From: Amanda Scholes on behalf of Planning.Responses
Sent: 18 July 2018 09:59
To: Planning Scanning
Subject: FW: Hares Dihatsu, Rustington

From: Anita Gardner
Sent: 17 July 2018 16:33
To: Planning.Responses
Subject: FW: Hares Dihatsu, Rustington

Please treat as a consultee response

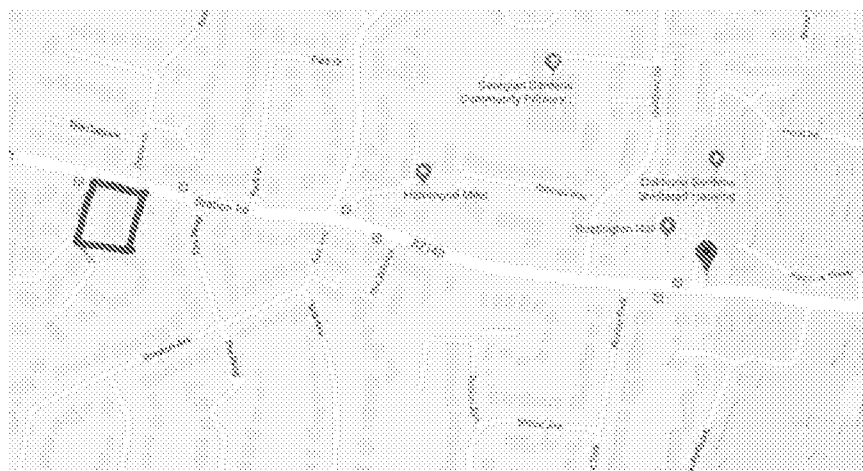
I have found another site, down the road on Station Road. This time the site is slightly to the East. Please find attached documents relating to drainage, including correspondence from yourself. I have added a screenshot of the location relative to our site.

The topo levels are similar to our site and they are using 3m deep soakaways.

I note that their recoding of groundwater was in March as per your email, whereas ours was April. You have not requested further winter groundwater monitoring on this scheme and instead referred to safety factors, despite their proposal to use relatively deep soakaways. We are only using permeable paving at surface level rather than 3m deep soakaways, so I would hope that whatever safety factors they are allowed to use could be applied to our site as well.

Please can you consider the monitoring requirement in the light of this information plus the previous email I sent relating to the site to the West of ours.

March is within the time frame that we allow for infiltration testing and groundwater monitoring, April is not. This is set out in our guidance.

However, as stated within my consultation response further discussion and safety factors were required as March was after the peak of groundwater levels. Your statement below over simplifies the situation at this site.

You are also planning on discharging to a foul sewer. Which is what I want to remove, in line with Building Regulations and CIRIA I would like you to follow the hierarchy for surface water drainage disposal. You have not done this, and infiltration testing is required to show if it is possible to infiltrate more surface water. I asked if there were neighbouring sites to try to remove the need for this further testing. However, no sites are in true close proximity to the site.

The two sites that you have highlighted hint that infiltration for all surface water is achievable, but it seems likely it will need to be at a greater depth to get to more permeable layers. You will need to complete testing at the right depths in the winter to ascertain if this is indeed the case. I would recommend you contact me before you commence this to ensure it meets our requirements.
